*Comment Received From: Statewide Utility Codes and Standards Enhancement Team
Submitted On: 6/18/2021
Docket Number: 21-BSTD-01*

Comments on Indoor Lighting Beauty Salon

Comment on Nonresidential Lighting for 45-Day Language

2. Update to Barber, Beauty Salon, Spa Area Category LPD

Figure 1: Small Beauty Salon

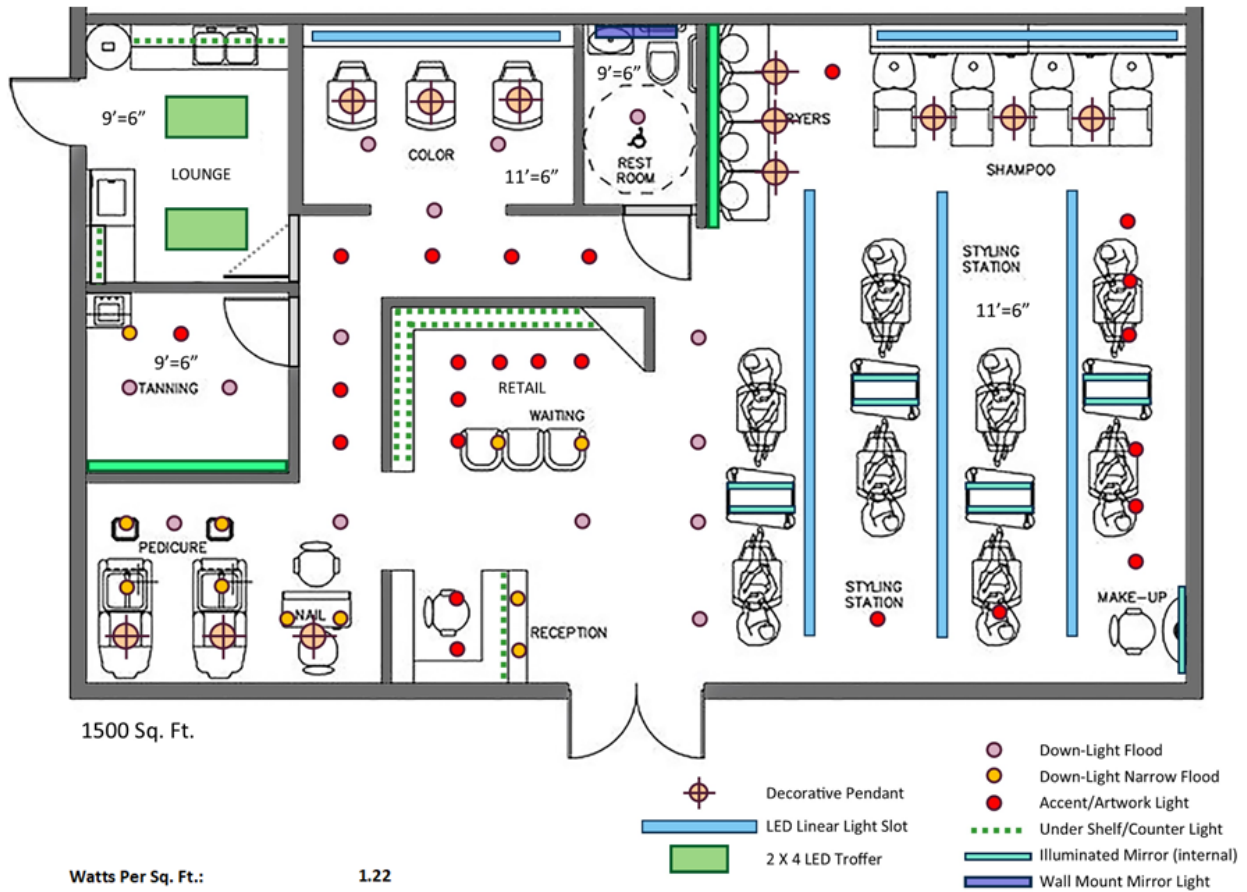
The Statewide CASE Team is recommending that general lighting LPD be increased from 0.65 W/ft² to 0.70 W/ft² and the detailed task allowance from 0.20 W/ft² to 0.30 W/ft² and display/decorative allowance remain the same at 0.25 W/ft² for a maximum allowable LPD of 1.25 W/ft². The rationale is to allow “high end” designs for spas and the like where lighting is providing not only high light levels for beauty salon tasks, such as hair cutting and with high color rendering index for hair tinting, but also decorative and display lighting for illuminating artwork and with additional light sources, such as lights that are built into mirrors. A graphic of these designs is shown in Figure 1.

As the calculation in the graphic shows, this design, which has design features in demand by some of the beauty salons, cannot meet the 45-Day Express Terms total wattage target of 1.10 W/ft². This design includes circulation lighting, task lighting above the various workstations, includes illuminated mirrors, display lighting or artwork, and task lighting for the financial transaction. There are many activities and different tasks occurring within a relatively small space. This design could barely comply if higher efficacy but lower quality light sources with a color fidelity of only 80 CRI were used. This would not be keeping with the intent of providing comparable amenity with less energy.

Statewide CASE Team recommends a moderate increase in the LPD in the 45-Day Express Terms but less than the LPDs in the 2019 Title 24, Part 6 Standards.

Figure 2: Luxury Beauty Parlor/ Spa.

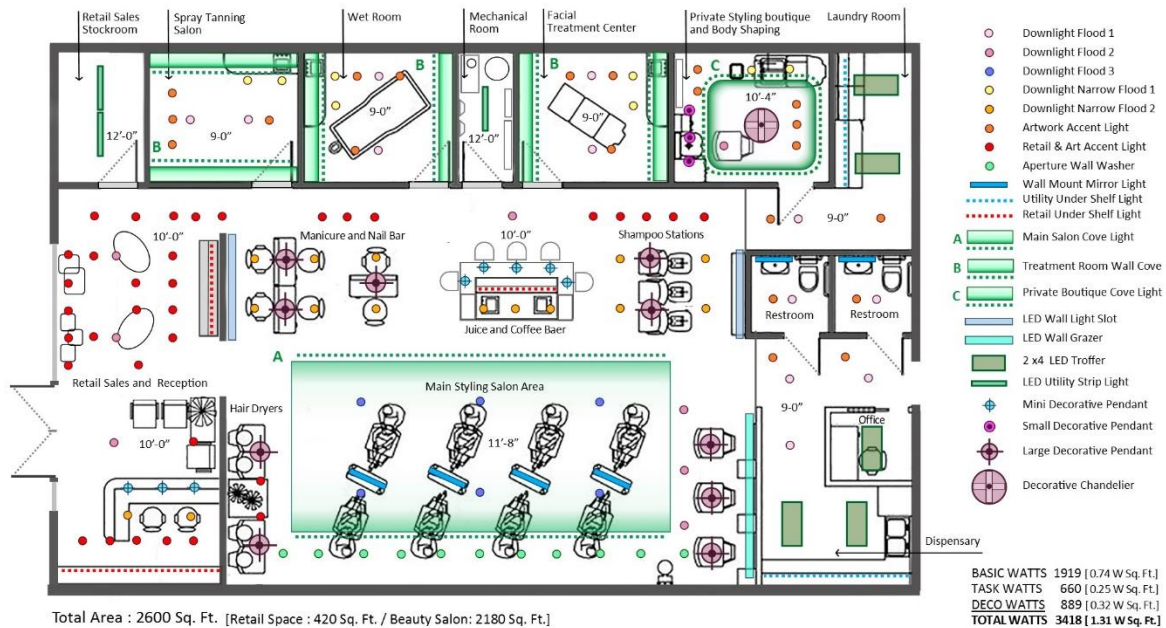
The revised lighting wattage allowance is proposed in lieu of having a Tailored Lighting Method approach for high end beauty salons. The sample designs developed here would accommodate most predicted needs for beauty salons. If even more lighting power was desired as shown in the luxury design in Figure 2 with lighting power density of 1.31 W/ft², this could be accommodated by installing institutional tuning the lighting and making use of the 10 percent power adjustment factor and drop the adjusted lighting power to 1.18 W/ft².
